MEMORANDUM

To [REDACTED] | City of Ballarat
From [REDACTED] | Water Technology
Date 18 June 2026
Subject Ballarat 11 Waterways Amendment C217ball – Beveridge Williams Consolidated Response
Our ref 26010601_M01_V01_BevWil.docx

1 SCOPE OF MEMORANDUM

Figure 1 Canadian Creek & Tributaries Drainage Infrastructure – Elsworth/Butt Street (UIL – upstream invert level, DIL – downstream invert level)

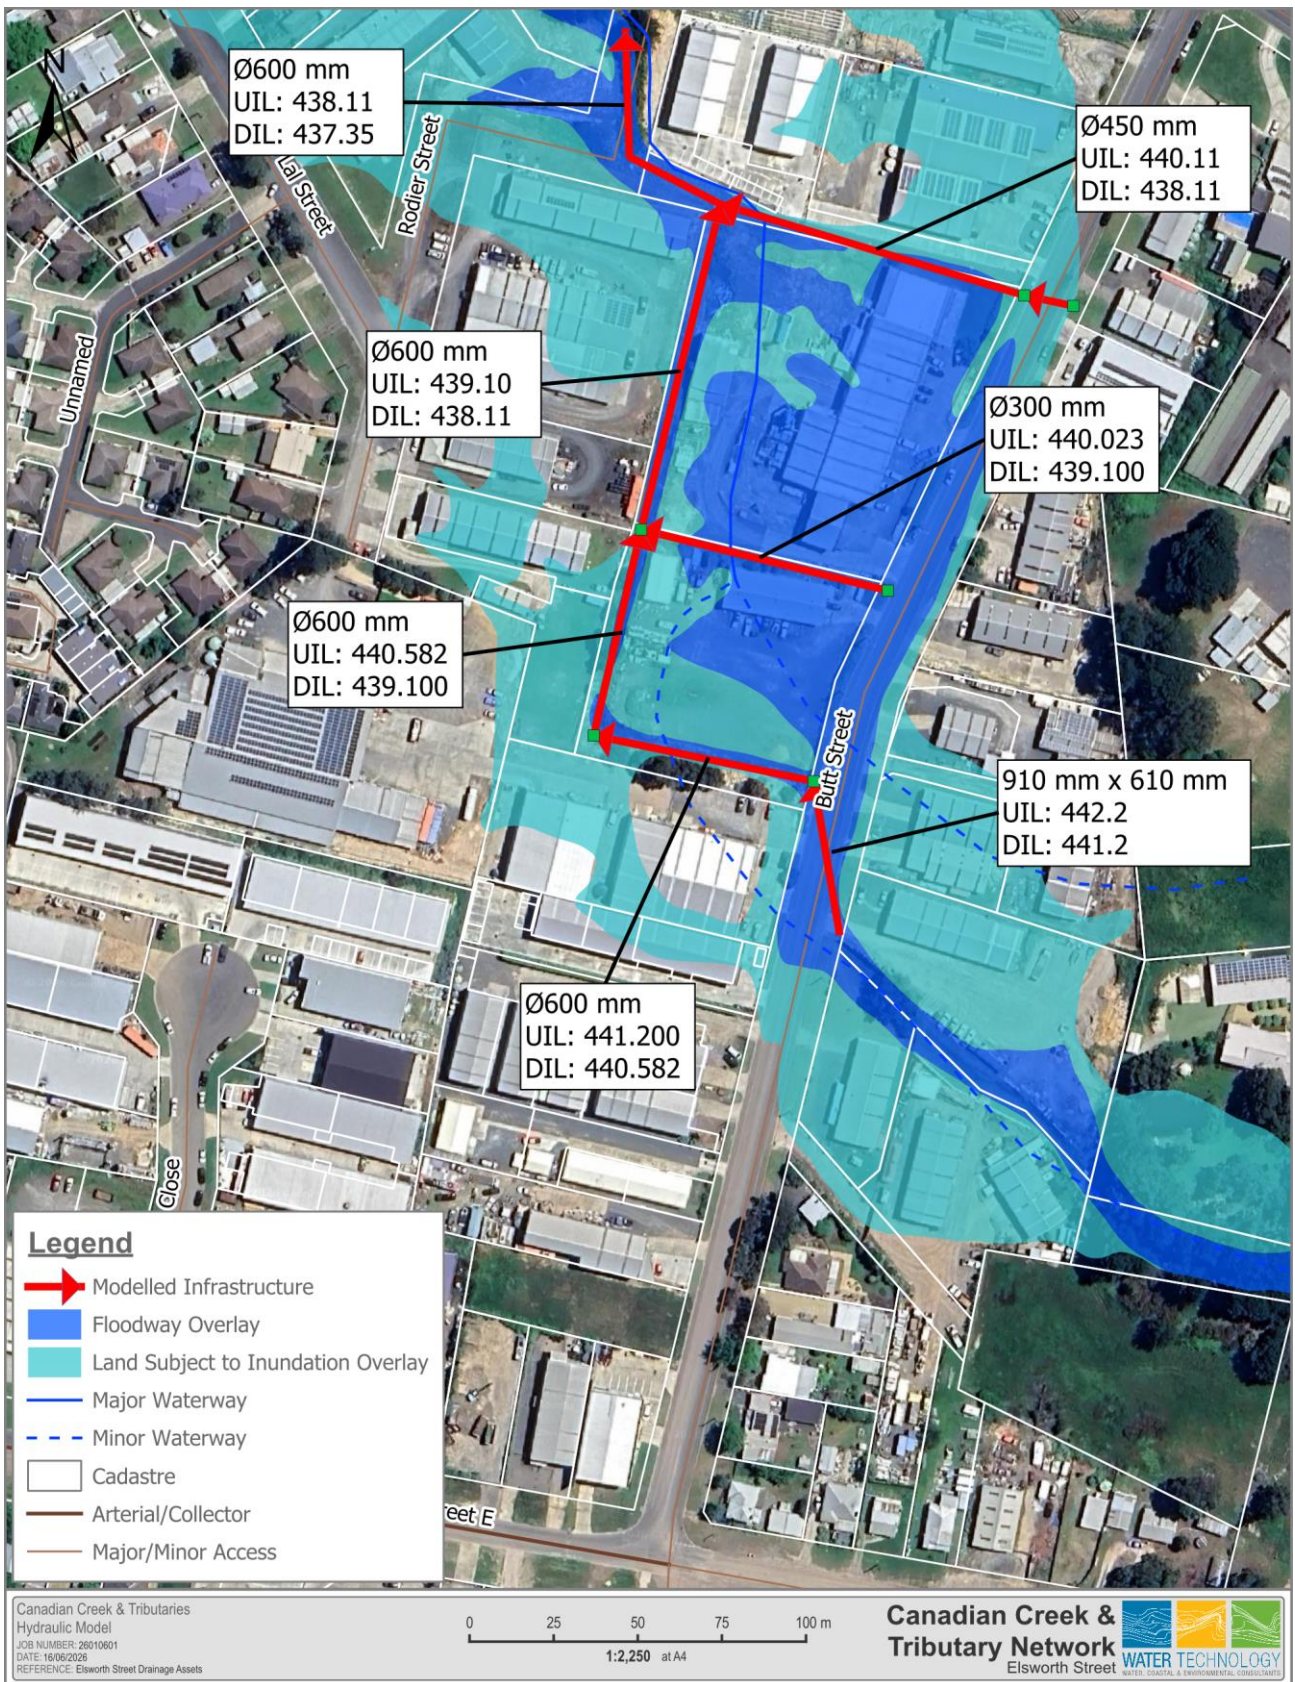
2.1.1 Completeness and representation of the drainage infrastructure

The extent of the stormwater drainage infrastructure within the hydraulic models was limited to the riverine extents. Inflows from the hydrological models were applied directly to the waterways, or in some instances into drainage infrastructure. Inclusion of the stormwater drainage infrastructure outside of these areas was not necessary as it would not impact the outcomes of the study. An overview of the stormwater drainage infrastructure included in the Canadian Creek & Tributaries hydraulic model (specific to Elsworth and Butt Street) is shown below in Figure 1.

Figure 4 Terrain Comparison – Cross-Section 1

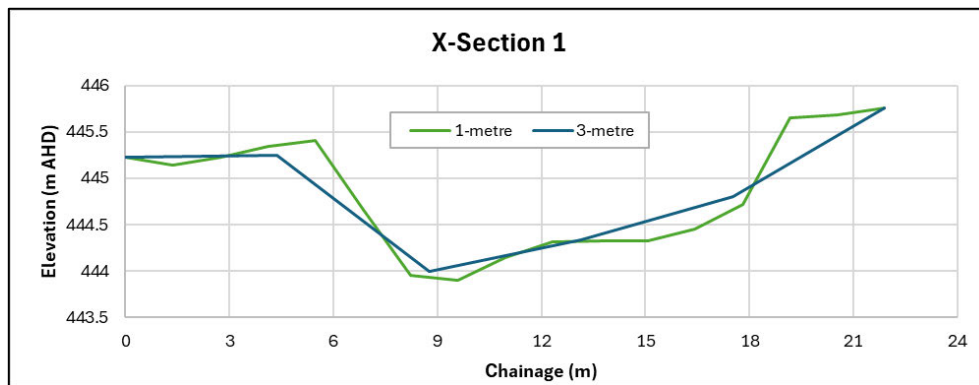
2.1.2 Treatment of terrain resolution (LiDAR resampling)

Specific to the abovementioned site, the overland flow paths from the upper catchment to Butt Street does not include a 1D channel. A comparison of the input terrain data (1-metre) and modelled terrain (3-metre) is shown below to demonstrate that while some accuracy in the terrain characteristics is lost, it is a common issue in large flood models and does not invalidate the results.

Figure 3 below provides an overview of the cross-section locations where the comparison has been undertaken and features the 1-metre topographical dataset. Comparison cross-sections for each location are presented in Figure 4, Figure 5, Figure 6 and Figure 7.
